United States Patent and Trademark Office

APPLICATION NO.	FILING	DATE	FIRST NAMED INVENTOR	ATTORNEY DOCKET NO.	CONFIRMATION NO.
10/645,605	08/22/	/2003	Egon Blum	2003-1109A	8589
513	7590	09/07/2006		EXAMINER	
	OTH, LIND &	HANSEN, JAM	HANSEN, JAMES ORVILLE		
2033 K STR SUITE 800	EET N. W.		ART UNIT	PAPER NUMBER	
WASHINGT	ON, DC 200	006-1021	3637		
				DATE MAILED: 09/07/2006

DETAILED ACTION

Fig. 7

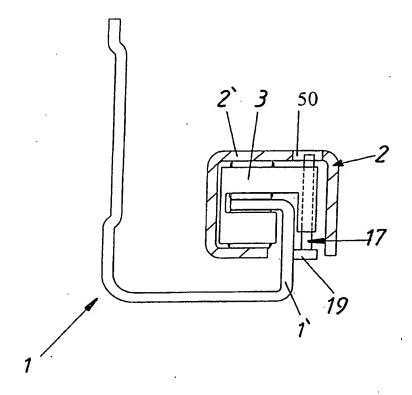
- 4. Claims 22, 33-39, 41, 43 & 44 are rejected under 35 U.S.C. 102(b) as being anticipated by Rock et al., [U.S. Patent No. 4,089,567]. Rock (figures 1-12) teaches of a pull-out guide assembly for a drawer, comprising: a support rail (1) to be mounted on a carcass (fixed structure e.g.,); a pull-out rail (4) to be mounted on the drawer (drawer e.g.,); and a running carriage (6) mounted between the support rail and the pull-out rail and operable to move between a front end position and a rear end position in a differential manner, the running carriage including: rollers (7) for transmitting a load of the drawer between the support rail and the pull-out rail; and a locking device (viewed as 22 and it's engaged components) operable to lock the

running carriage to the support rail at a first predetermined point (viewed as the point where element 26 engages with element 14', so far as broadly recited) located between the front end position and the rear end position, and operable to unlock the running carriage from the support rail at a second predetermined point (viewed as the point where element 18 engages with the slanted edge of element 22, so far as broadly recited) located between the front end position and the rear end position due to relative movement between the support rail and the pull-out rail (pull-out rail pushed in an engaging an element of the locking device); wherein the support rail, the pull-out rail, and the running carriage are arranged and interconnected such that, if the running carriage is locked to the support rail at the first predetermined point by the locking device while moving toward the rear end position (it is viewed that there is some "play" or tolerance between the engagement of element 26 with 14', thereby the carriage could be viewed as "moving" [albeit minimally] while still locked to the rail as the lever (22) is transferred from the locked state to a released state], the running carriage is operable to continue moving toward the rear end position in the differential manner after being unlocked by the locking device at the second predetermined point, as readily apparent to the examiner. As to claim 33, the pull-out rail has a stop (18) and the support rail has a deflection unit (viewed as 14') for receiving the locking device. As to claim 34, the deflection unit comprises an opening in a horizontal web of the support rail as readily apparent to the examiner. As to claim 35, the stop comprises a first stop (1st 18), while the support rail has a second stop (viewed as an edge of 14), the second stop comprising an edge of the opening. As to claim 36, the stop comprises a horizontal tab (viewed as a horizontal tab since the tab is located on in a horizontal plane). As to claim 37, the locking device comprises a rocker (22, 24)

tiltably mounted on the running carriage, the rocker having two stop faces (face of 26 and face on the bottom on 22) shaped to abut against a stop (edge of 14' and 18) on each of the support rail and the pull-out rail respectively. As to claim 38, the tiltable rocker has an adjustable shape (the shape is viewed as being adjustable when 24 flexes). As to claim 39, the tiltable rocker comprises a first part (main part 22) and a second part (spring part 24) connected to each other in an articulated manner, each of the first part and the second part having a stop face (as noted above). As to claim 41, one (note the portion between the upper surface of 26 and 22) of the stop faces is viewed as being concave, while the other (note the portion on the underside of 24) stop face is viewed as being convex. As to claim 43, the locking device is operable to lock the running carriage to the support rail at the first point if a position of the carriage with respect to the support rail and pull-out rail is incorrect, as best understood by the examiner. As to claim 44, the claimed limitations have been addressed as previously disclosed above.
